SUBJECT: REQUEST FOR ADDITIONAL INFORMATION FOR REVIEW OF THE MODEL  
NO. NPI-20WC-6 MkII PACKAGE

Request for Additional Information  
Docket No. 71-9215  
Model No. NPI-20WC-6 MkII

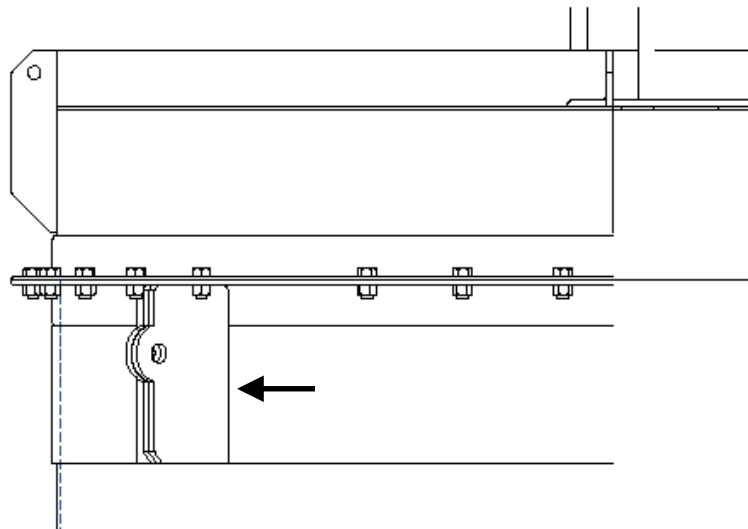
1. Identify the item, shown in the Figure below, at which the arrow is pointing.

The figure above was taken from view A-A in drawing 240116, Rev. H. Based upon its location relative to other package components shown in other views of the drawing, the item in the figure at which the arrow is pointing appears to be the tie down bracket. However, the addition of the tie down bracket to this view of the package was not identified in the changes made to the drawing and the item does not appear in previous revisions of drawing 240116. The drawing should be modified to identify this item.
